# APPLICATION

PERCOLATION TESTING

HOWARD COUNTY HEALTH DEPARTMENT  
BUREAU OF ENVIRONMENTAL HEALTH  
3525-H ELLICOTT MILLS DRIVE/ELLICOTT CITY, MARYLAND 21043  
TELEPHONE: 313-2640

SUBDIVISION ESTATE OF RHODA FINE LOT NO. (2)

7397.  
p. lot 2

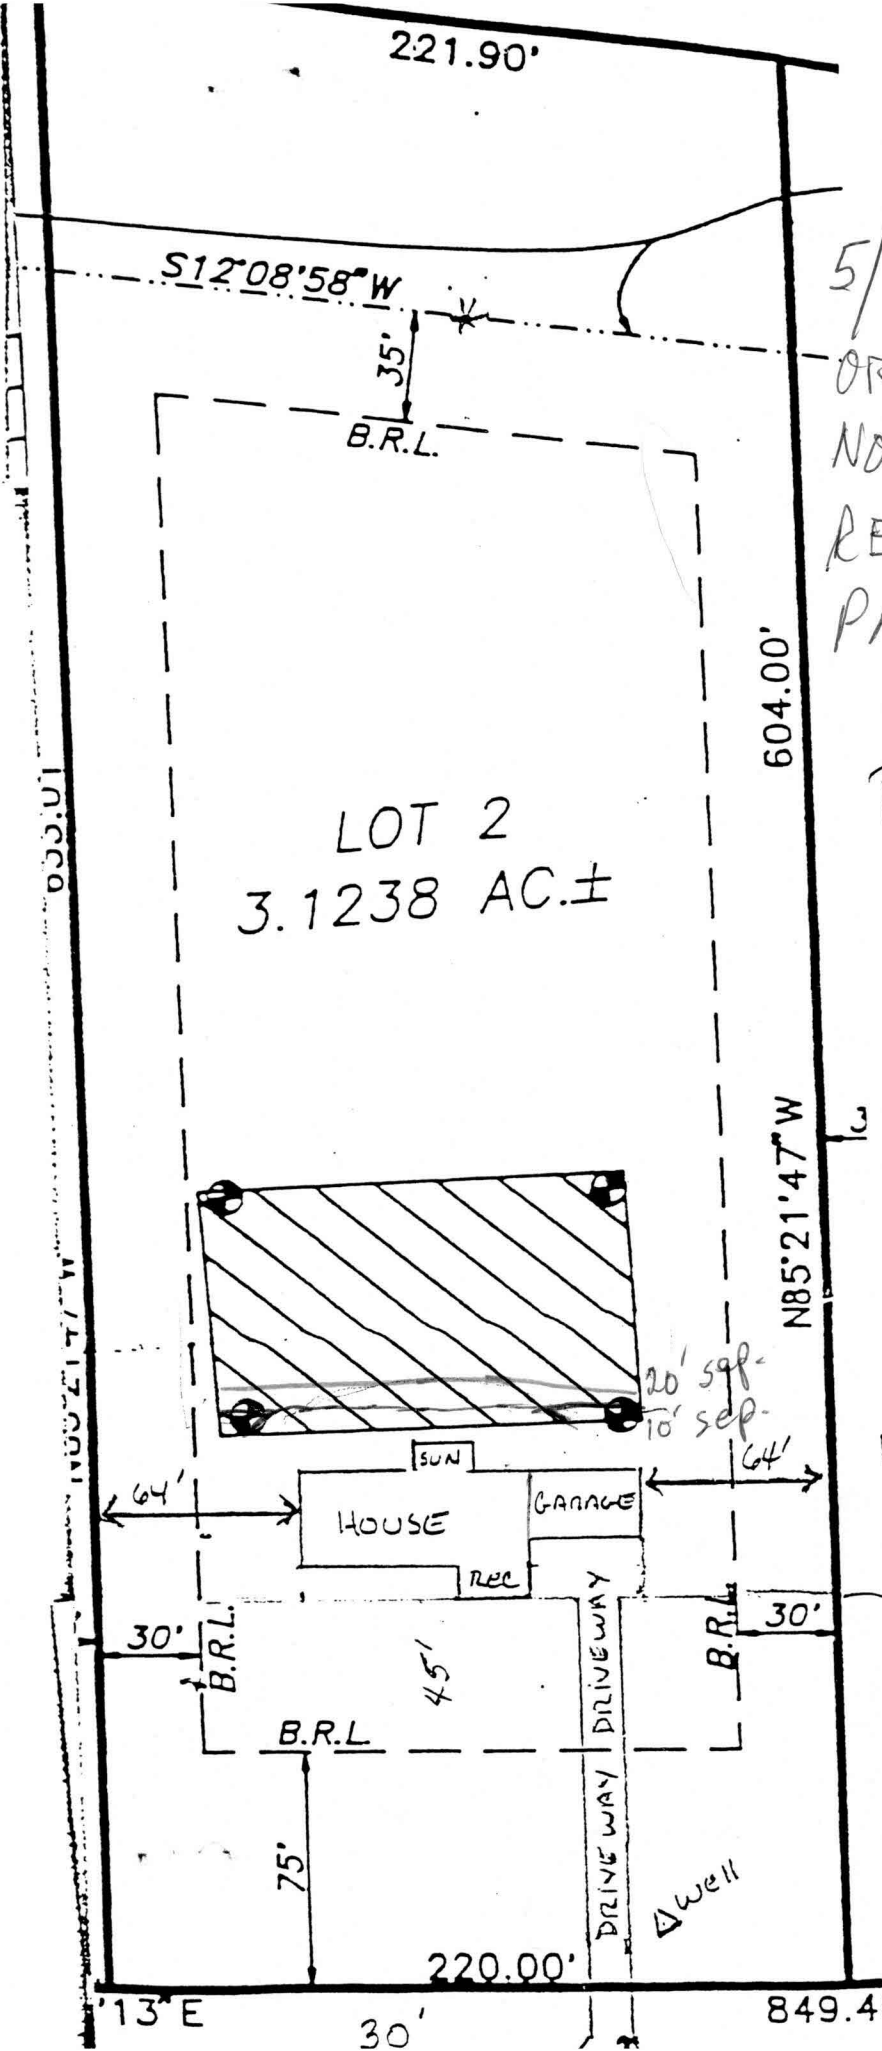
Ray Everett  
Wants to adjust septic  
are to place house as  
shown -

T/c w/ builder Cary Cumberland  
& Ray Everett - sun room  
is on foundation - 20'  
separation req'd

submit revised plot plan  
be advised no practical pool  
location - suggest major  
SRA adjustment via re-perc

From: \_\_\_\_\_  
pumping suggested

5/30/01 T/cw/builder  
 ORIG. PROPOSAL @ BP  
 NOT BEING  
 REVISED - OK TO  
 PROCEED (MP)

T/c to Ray E: OK - send amended
